# Technical Bulletin T163

**Product:** A/V Receiver

**Hardware Technical Bulletin:** T163-H2004-02

**Subject:** HDTV Component  
Video change

Figure1

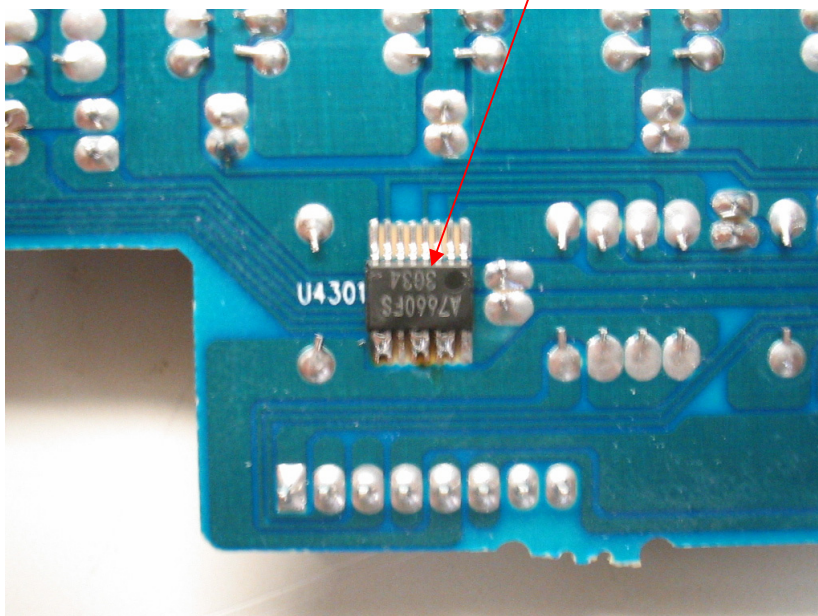
On the component video PCB U4301

- A) Link the following pins on U4301;
- Pins 9 to 10
  - Pins 12 to 13
  - Pins 14 to 15

Figure 2

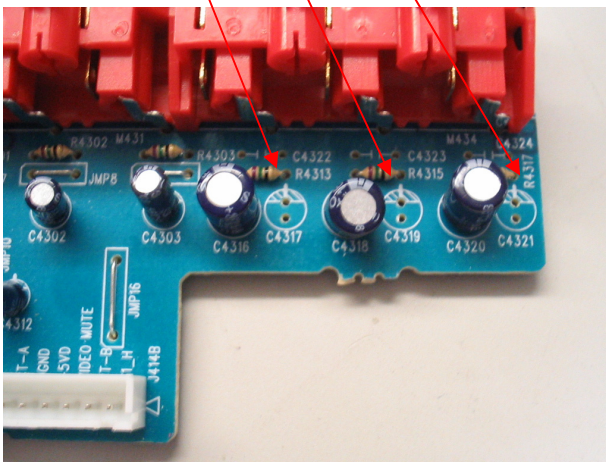
B) Remove C4317, C4319, C4321.

Figure 3

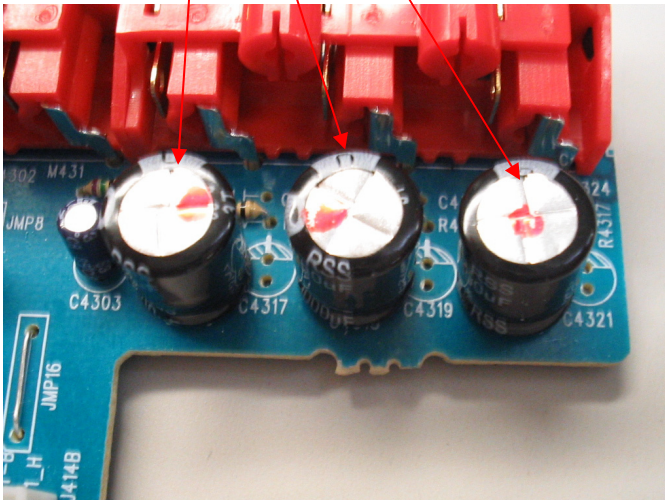
C) Replace C4316, C4318, and C4320 with 1000 uF 6V.
